W/X 166 – Sealing bodyshell openings Page 1-19

Date of issue: 2016.10.21 GSP/TPB I

1. BR166 - Sealing bodyshell openings

Fault location A-pillar, center, inside Bodyshell holes open Bodyshell holes sealed Item number A 006 989 30 85

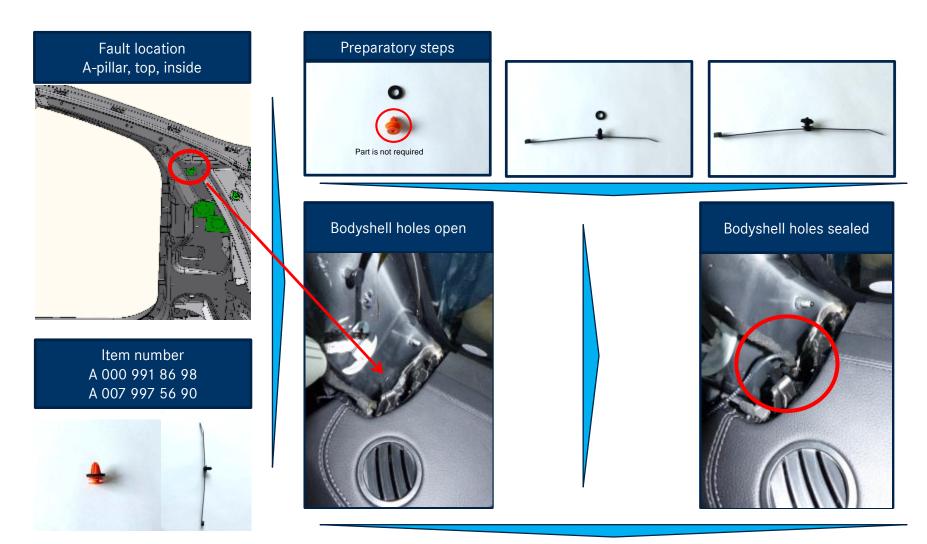
Note: Perform task on left-hand side. Check right-hand side (depending on equipment variant). Remove seal (black) of the plastic clip (orange) and install onto the cable strap to seal. Disconnect the cable fastening fixture from the cable harness (e.g. using side cutting pliers) and fasten with the prepared cable strap

Note: Perform task on left-hand side. Check right-hand side (depending on equipment variant). Remove seal (black) of the plastic clip (orange) and install on the cable strap to seal. Disconnect the cable fastening fixture from the cable harness (e.g. using side cutting pliers) and fasten with the prepared cable strap

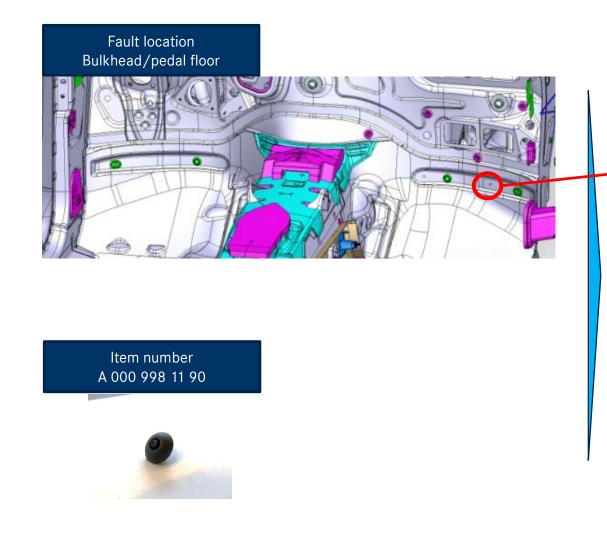
Note: Perform task on left- and right-hand sides

Bodyshell hole open

Bodyshell hole sealed

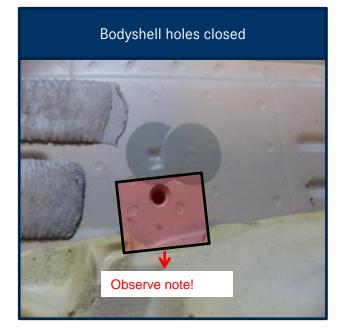
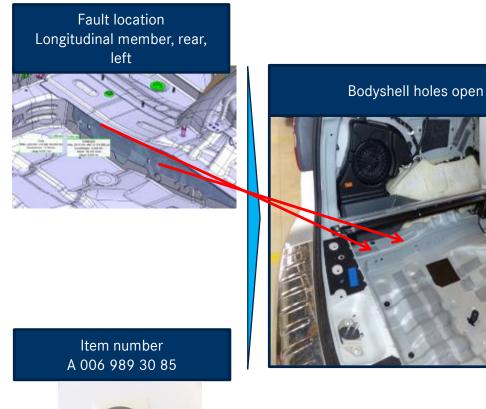
Note: Perform task on left- and right-hand sides. Bodyshell openings may or may not be present depending on the production year. Variant X166 has one additional bodyshell opening which must also be sealed.

Note: Perform task on left- and right-hand sides. <u>Caution:</u> It must be ensured that there is no adhesive tape between the bodyshell and the seat belt holder (black). Adapt adhesive tape.

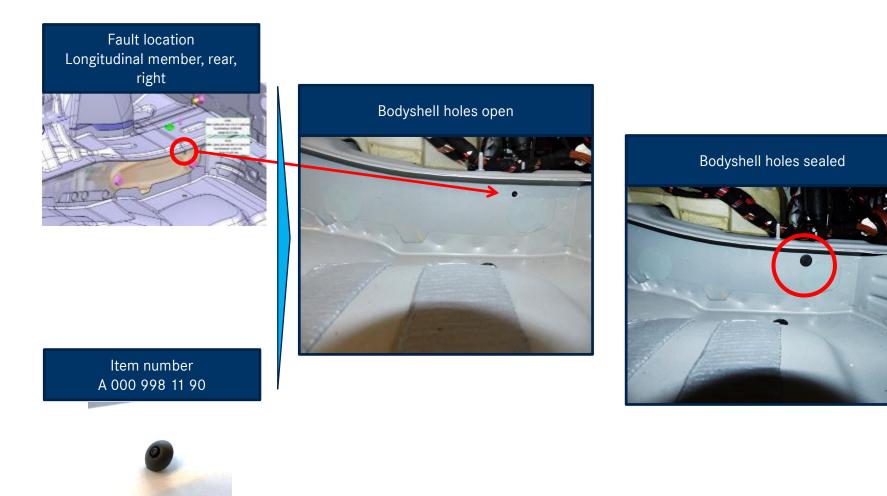
Note: Perform task on left-hand side. Two bodyshell holes are sealed with screws on vehicles with a trailer hitch. Variant X166 has one additional bodyshell opening which must also be sealed.

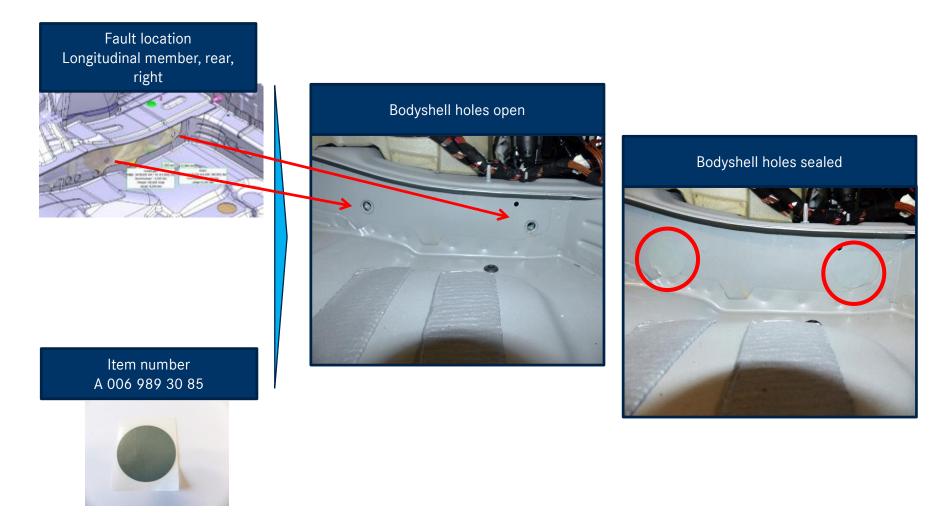
Note: Bodyshell opening only present on right-hand side. On variant X166, the bodyshell opening is located further forward in the direction of travel.

Note: Perform task on right-hand side. Two bodyshell holes are sealed with screws on vehicles with a trailer hitch. Variant X166 has one additional bodyshell opening which must also be sealed.
